Docket No. 52-048

**SUBJECT:** NuScale Power, LLC Supplemental Response to NRC Request for Additional Information No. 58 (eRAI No. 8835) on the NuScale Design Certification Application

NuScale Supplemental Response to NRC Request for Additional Information eRAI No. 8835

**Figure 4.6-1: Overview of Control Rod Drive Mechanism Locations in Relation to the Reactor Pressure Vessel and Containment Vessel**

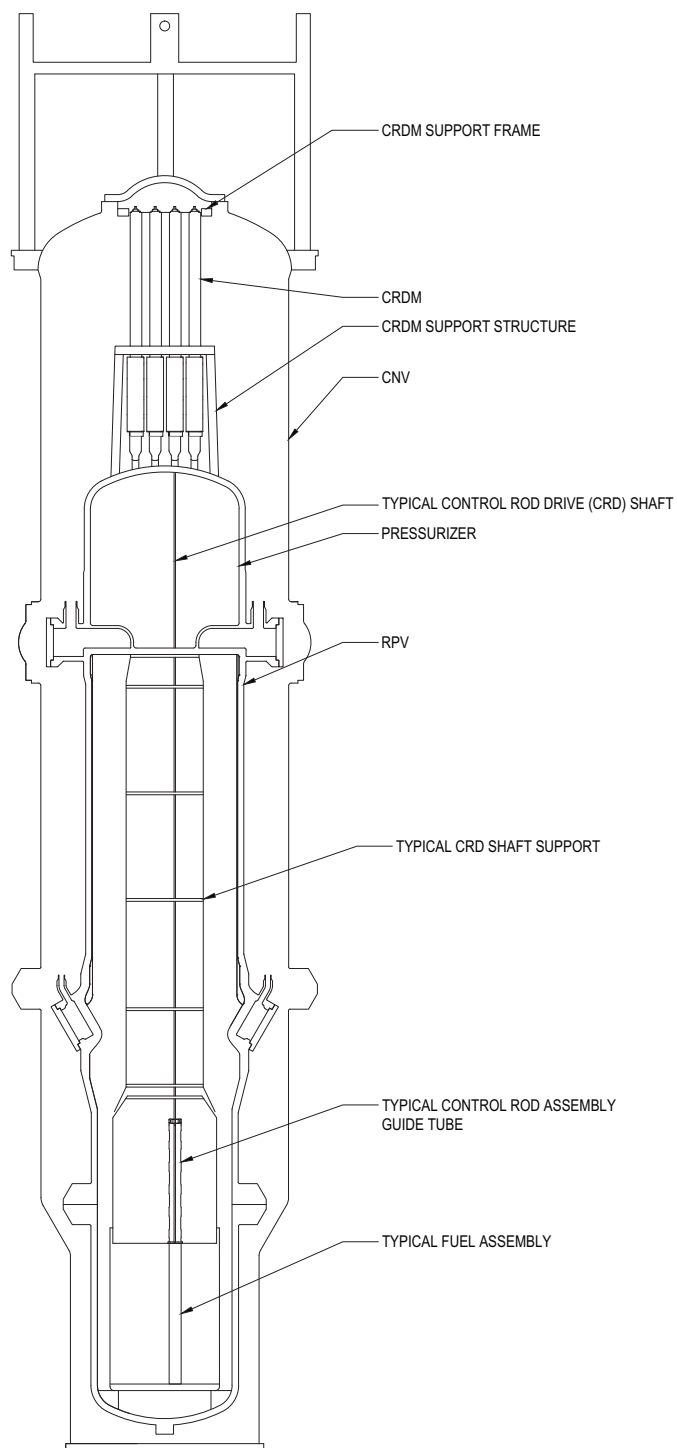
CRDM support structures are shown in Figure 4.6-1, and DCD Tier 2 Section 3.9.3.1.2 briefly mentions the CRDM seismic supports located on both the RPV and CNV head as ASME Code Class 1, Seismic Category I component supports. However, Figure 5.1-1 also illustrates the CRDM support structures, showing a different number of support structures than Figure 4.6-1. Additionally, DCD Tier 2 Section 3.9.4 does not discuss these support structures or any other means in which the CRDS is supported, despite discussion in the DCD regarding the very long length of the control rod drive shafts when compared to traditional large light water reactors. Provide an explanation of the support configuration in order for staff to make a safety finding for the review area of GDC 1 and 2.

A description of the CRDM support structures was provided in the response to eRAI 8835, Question 03.09.04-4 in RAIO-0817-55329, dated August 7, 2017 (ML17219A749). This information has been added to FSAR Section 3.9.4.1 in response to an NRC request during a September 13, 2017 public meeting.

**Figure 4.6-2: Control Rod Drive Mechanism Coils and Housings**

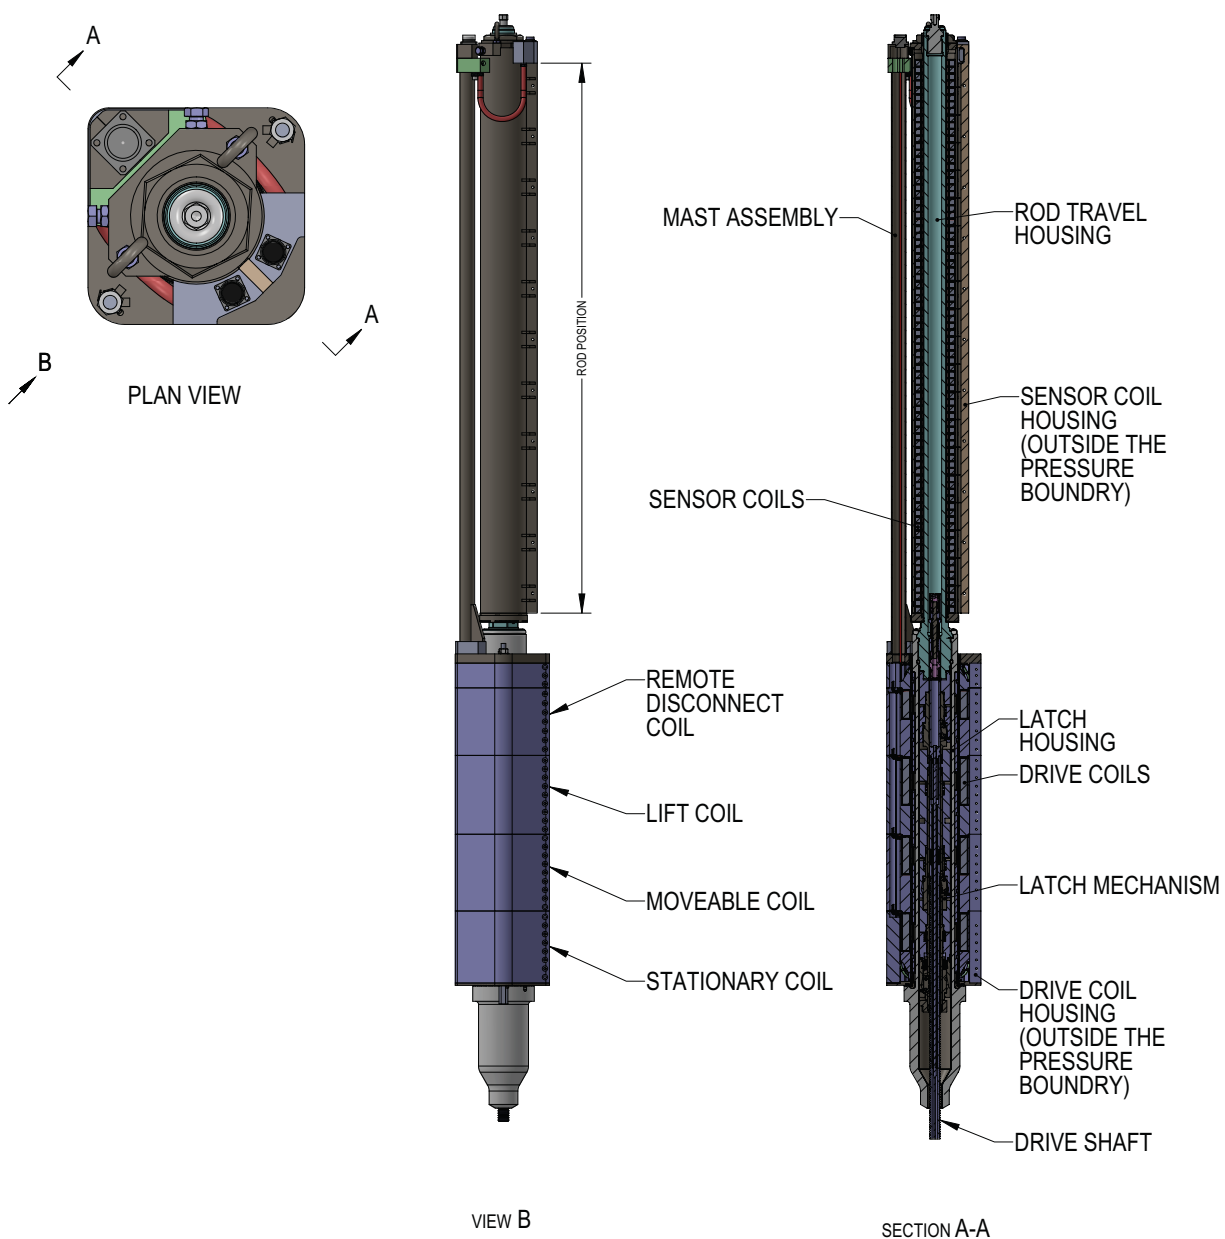
Very little technical information in Figure 4.6-2 is legible. Tier 2 Section 3.9.4.1.1 of the NuScale DCD states:

An update to FSAR Figure 4.6-2 was discussed in the response to eRAI 8835, Question 03.09.04-41 in RAIO-0817-55329, dated August 7, 2017 (ML17219A749). The updated Figure was inadvertently omitted from the FSAR update included with the eRAI 8835 response. FSAR Figure 4.6-2, included in this supplementary response provides a broader overview of the CRDM components. Additionally, FSAR Sections 1.5, 3.9.4, 4.2, 4.4 and 4.6 and associated Figures 3.9-1, 3.9-2, 4.6.1 and 4.6-2 are revised to consistently refer to the "control rod drive shaft." These changes were discussed during a September 13, 2017 public meeting.

**Figure 4.6-6: Control Rod Drive Mechanism Drive Shaft Interface with Control Rod Assembly**

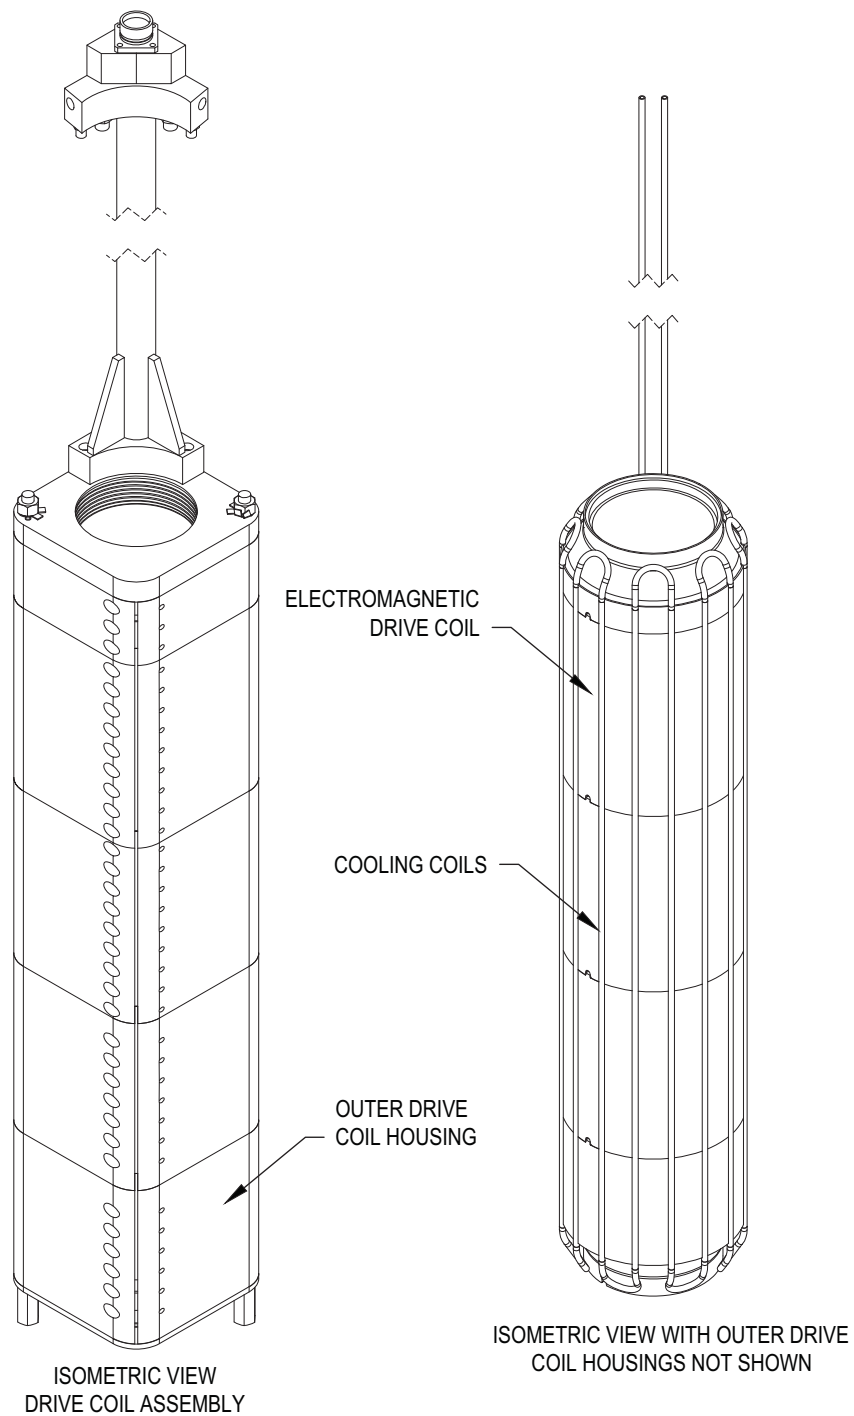
Additional detail on the method of operations is required to make a safety finding for GDC 26, 27, and 29. Statements like “coils are energized in the sequence,” when describing the stepping process provide an insufficient level of detail to make a determination that the operation sequence does not place the system in a non-fail-safe configuration. Provide additional detail on the configuration of the latching mechanism (e.g. how many latches per mechanism, redundancies present in function, etc.). Include specific language to indicate that the CRA drops fully into the core and that the reactor trip function is achievable during any part of the insertion/withdrawal sequence under all design conditions in the discussion of the reactor trip function. Examples of more detailed discussion methods of operation may be found in the DCDs for other design centers, such as AP1000 or EPR.

The remote disconnect mechanism (RDM) subsection added to the FSAR discussed in the response to eRAI 8835, Question 03.09.04-4 in RAIO-0817-55329, dated August 7, 2017 (ML17219A749), has been revised to address NRC comments provided during a September 13, 2017 public meeting. Figure 4.6-6 has been updated to more clearly depict operation of the remote disconnect mechanism. Additional detail has been added to Section 3.9.4.1.1 to describe the remote disconnect process, including discussion of RDM component operation and configuration during each step of remote disconnect operation. A similar detailed discussion of the remote engagement operation is also added to Section 3.9.4.1.1. Additionally, text discussing reactor trip operation that was removed by the FSAR change discussed by the response to eRAI 8835 has been restored. This change was also discussed during the August 7, 2017 public meeting.

FSAR Section 1.5.1.7 and Figure 4.6-6 have been revised as described in the response above and as shown in the markup provided in this response.
